**CITY OF MCMINNVILLE
PLANNING DEPARTMENT**
231 NE FIFTH STREET
MCMINNVILLE, OR 97128

DECISION, CONDITIONS, FINDINGS OF FACT AND CONCLUSIONARY FINDINGS OF THE MCMINNVILLE HISTORIC LANDMARKS COMMITTEE FOR THE APPROVAL OF A NEW BUILDING AT 631 NE 1ST STREET WITHIN THE DOWNTOWN DESIGN AREA

- DOCKET:** DDR 1-21 (Downtown Design Review for New Construction)
- REQUEST:** Approval of a Downtown Design Review application to allow for the construction of a new building at 631 NE 1st Street on a parcel that is currently vacant. The proposed work includes construction of the new building, parking areas, and drive aisles. The proposal includes a request for an exception to the typical front setback requirement to allow for a plaza/courtyard area in front of the building.

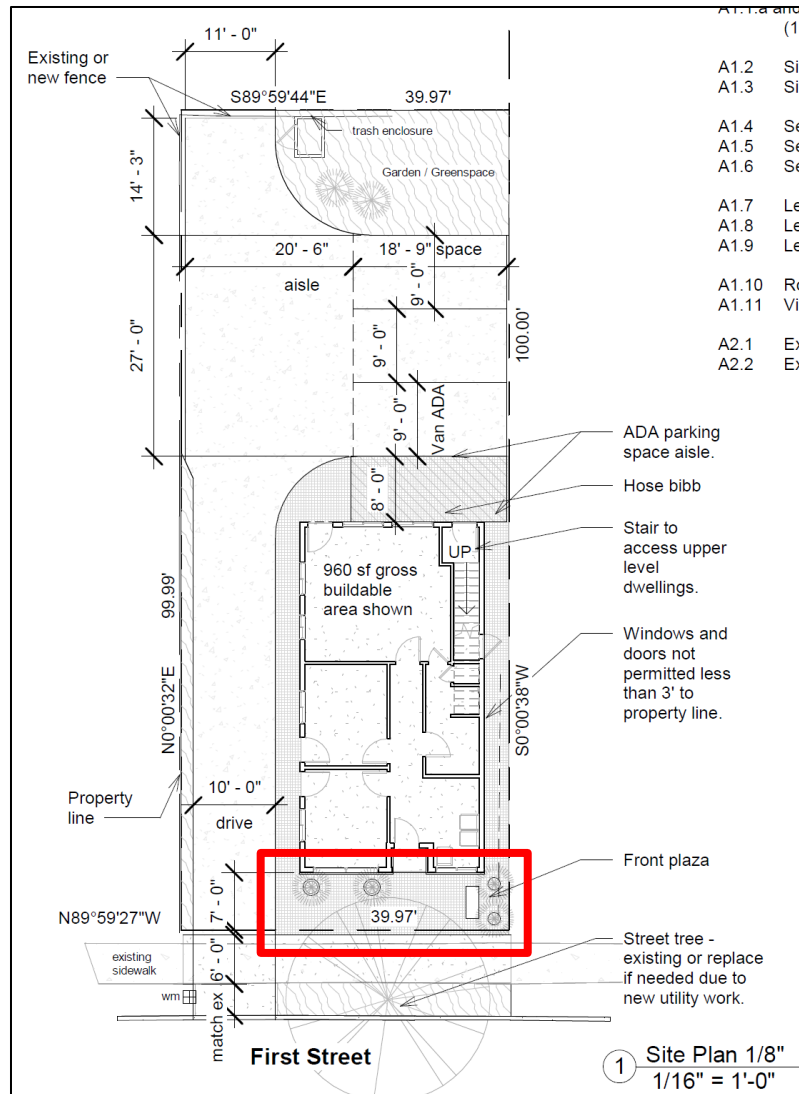
FINDING: SATISFIED WITH CONDITION #2. The City concurs with the applicant's findings, and allows for the exception to the zero foot setback from the property line based on the fact that the plaza space is being provided. The plaza space, and therefore the 7 foot setback, is allowed based on the reasoning provided by the applicant. The City adds that the applicant also provided visual examples of other plaza spaces that allowed for building setbacks within the Downtown Design Area. These examples of other plaza spaces are available within the application materials attached to this decision document (and on file with the Planning Department). In order to clearly identify this space as a plaza, a condition of approval is included to require that the plaza space be of a different material or finish (concrete scoring, etc.) to provide visual identification of the plaza space and differentiation between the plaza and the adjacent sidewalk and drive aisle spaces.

2. That the plaza space be of a different material or finish (concrete scoring, etc.) to provide visual identification of the plaza space and differentiation between the plaza and the adjacent sidewalk and drive aisle spaces.

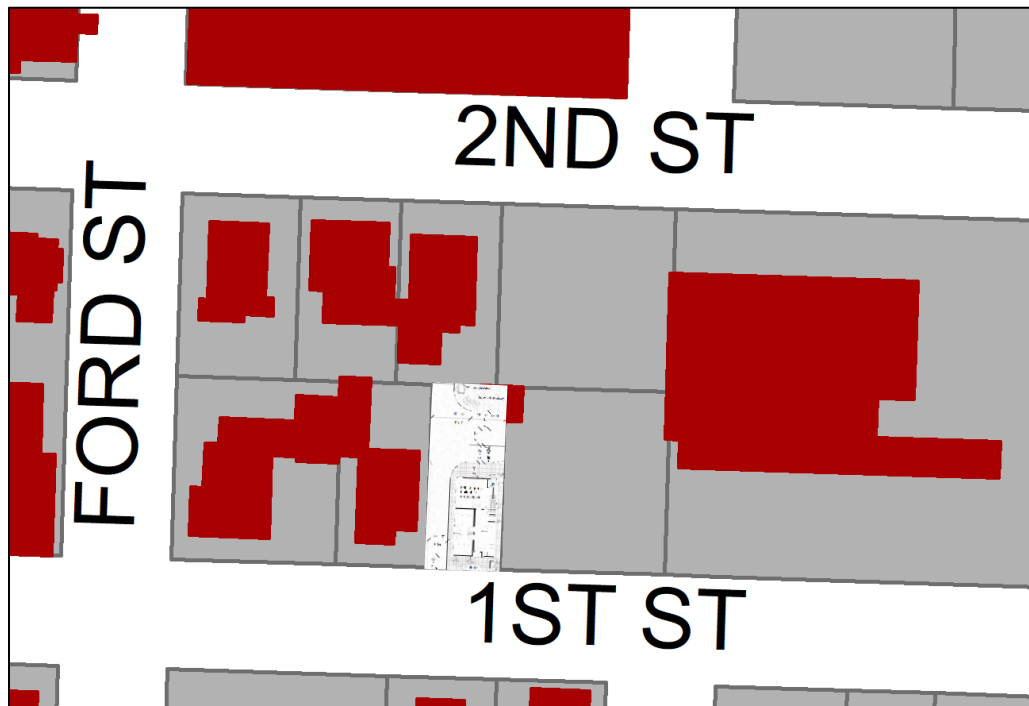
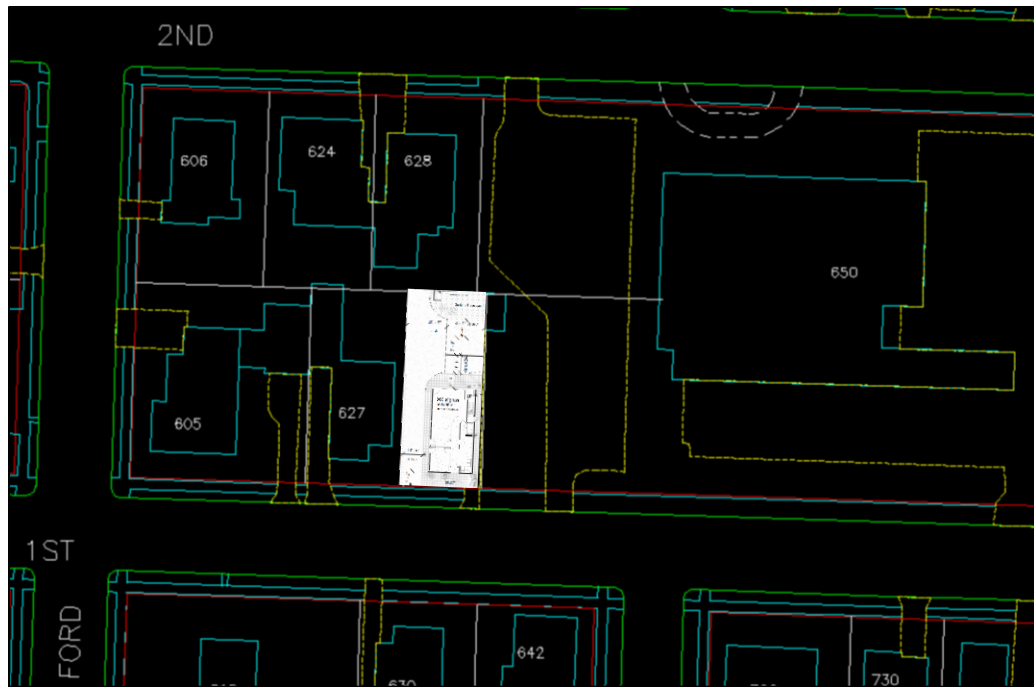
FINDING: SATISFIED. The City partially concurs with the applicant’s findings. The City concurs that the rectangular footprint and size of the footprint of the proposed building are similar in configuration to adjacent and nearby historic buildings on the same block. The City adds that the combination of the proposed building footprint size and location of the building on the lot will result in a similar configuration to the lots on which the adjacent historic buildings are located. The proposed configuration of the new building includes a slight setback that is not quite as large but is similar to adjacent historic buildings on the same block. The configuration of the proposed building on the lot also provides for other open spaces on the site that are similar to adjacent properties. These open spaces will allow for a plaza in the front of the building (usable front yard space), a driveway/drive aisle along the side of the building, parking areas behind the building, and a small usable green space behind the building similar to back yards of adjacent properties. This configuration and location of the building on the lot results in a similar proportion of the lot being covered with building footprint as exists on the lots of adjacent historic buildings.

In regards to massing, the City partially concurs with the applicant's findings. The City does acknowledge that the proposed design of the building, which meets the applicable Downtown Design Standards as described in the findings above and below, will result in a building that appears visually different from adjacent historic buildings on the same block. This is because, in this case, the existing historic buildings on the same block are residential buildings and uses. While different in visual appearance, the City finds that the overall massing of the proposed new building is similar to adjacent and nearby historic buildings on the same block. Besides the single story building immediately adjacent to the west, all other historic buildings on the same block are 2-2.5 stories, have square or rectangular building forms, and are of a height that is similar to the proposed new building when incorporating the maximum height of the peak of the gable or hipped roofs. The height of the proposed new building is approximately 34 feet. The exact heights of adjacent buildings is not known, but is estimated to be near 30 feet in height when measured to the roof peaks. The proposed new building includes a flat roofline in order to achieve the Downtown Design Standard in Section 17.59.050(B)(4), which also specifically discourages gable roof shapes or other residential roof forms. However, the overall massing of the proposed new building is similar to adjacent historic buildings on the same block, in that the height and building size is similar.

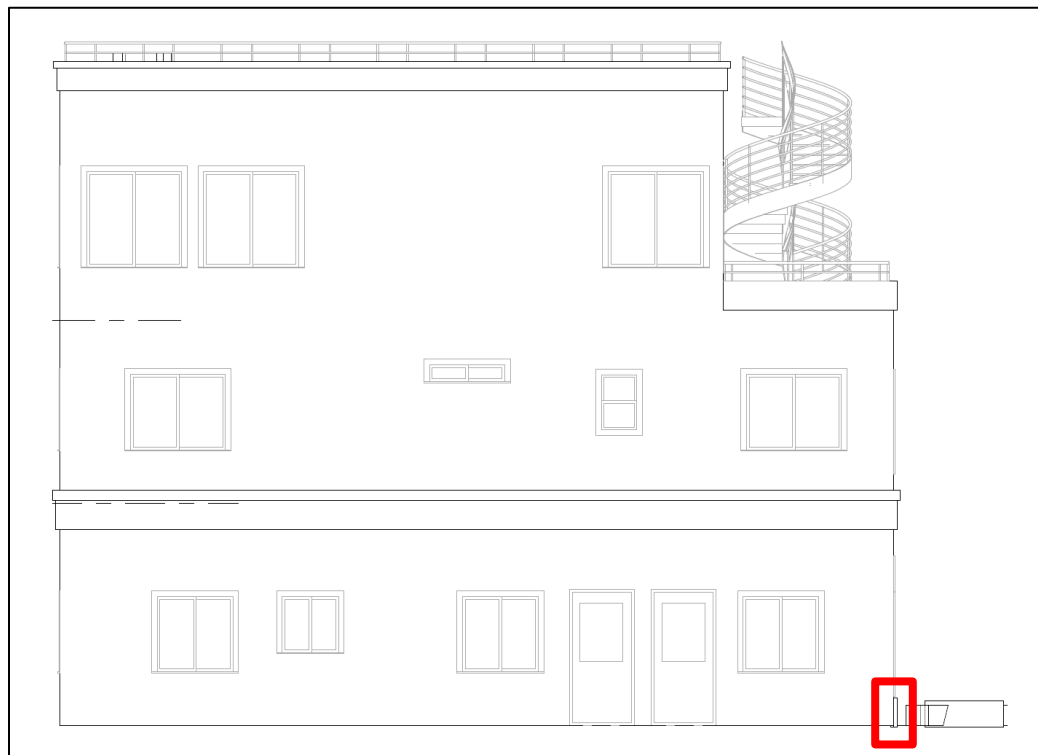
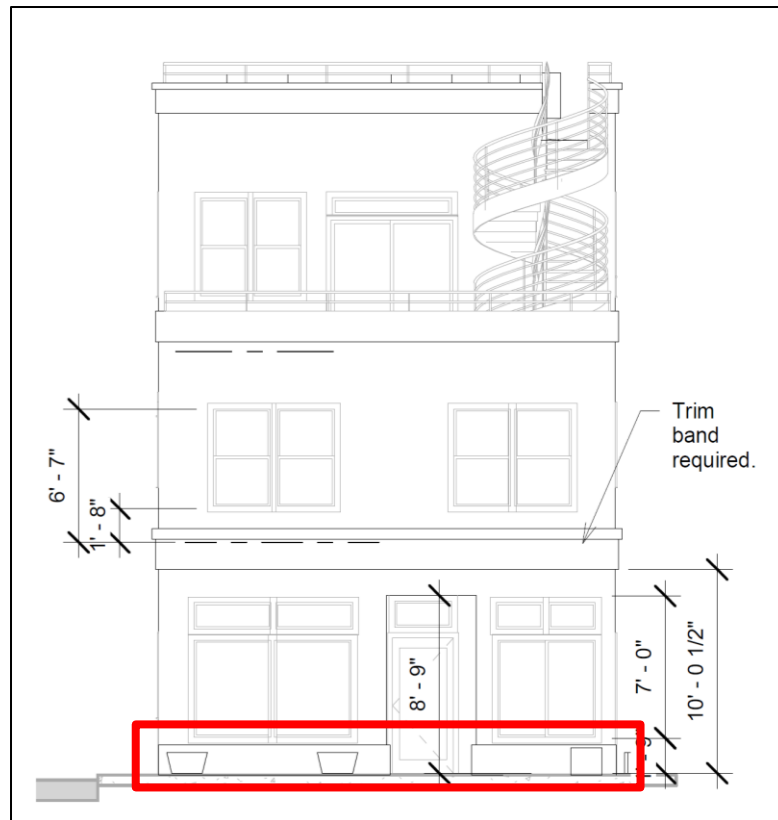
FINDING: SATISFIED. The City concurs with the applicant's findings. The bulkhead feature as identified in the front elevation has a dimensionality that extends outward from the remainder of the building wall. The stucco bulkhead proposed can be seen below:

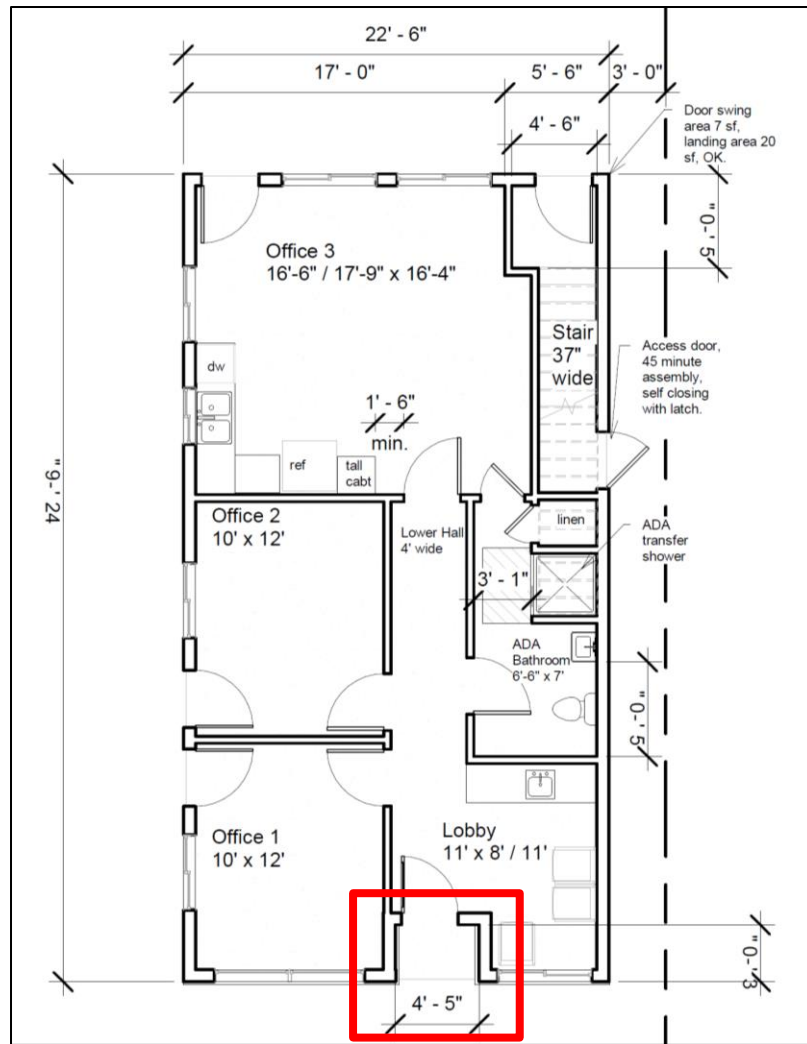
FINDING: SATISFIED. The City concurs with the applicant’s findings, but adds that the glazing below the transom line (which is 8’ 9” from grade) is approximately 137.83 square feet. Based on the façade width of 22.5’, the area below the transom line is approximately 196.875 square feet. Therefore, the amount of glazing below the transom line is just over 70%, and the amount of glazing below the horizontal belt course between the first and second stories (which is at just about 10’ in height) is approximately 61%.

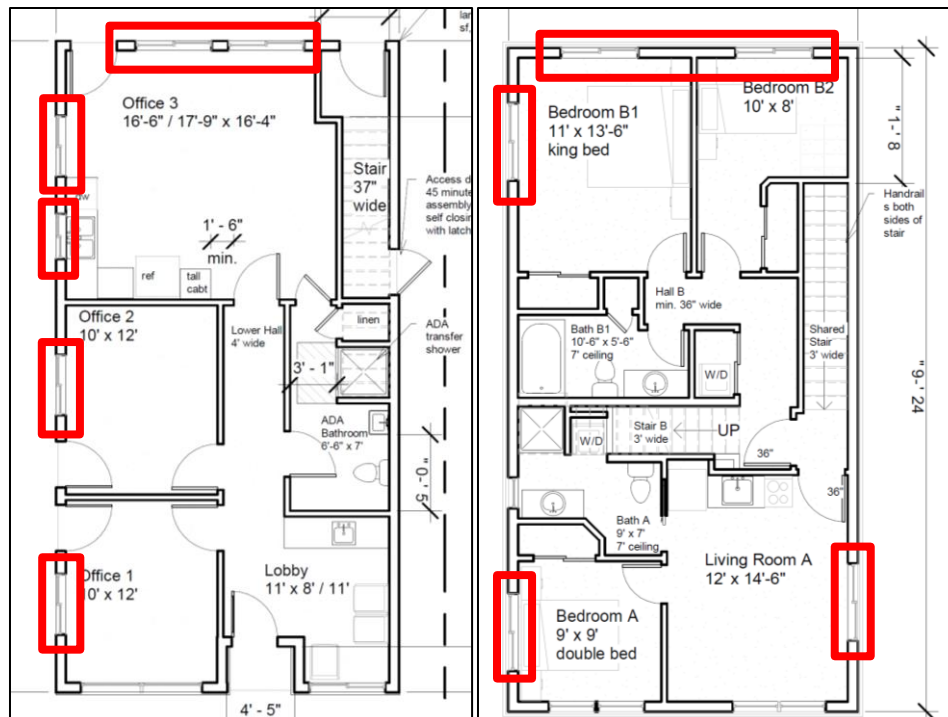
FINDING: SATISFIED WITH CONDITION #3. The City concurs with the applicant’s findings, but adds that the windows on the side elevations appear in the floor plans to be flush to the outside face of the building. A condition of approval is included to require that on the building permit construction plans submitted for the proposed building, all windows on the building shall be set flush to the inside face of the building so that they are recessed and not flush against the surface of the outer wall.

The floor plans and window locations shown in the floor plans can be seen below (note that the same applies to the third story, but only the first and second story are identified below). Areas where windows do not appear to be completely flush to the inside face of the building wall are identified.

3. That on the building permit construction plans submitted for the proposed building, all windows on the building shall be set flush to the inside face of the building so that they are recessed and not flush against the surface of the outer wall.
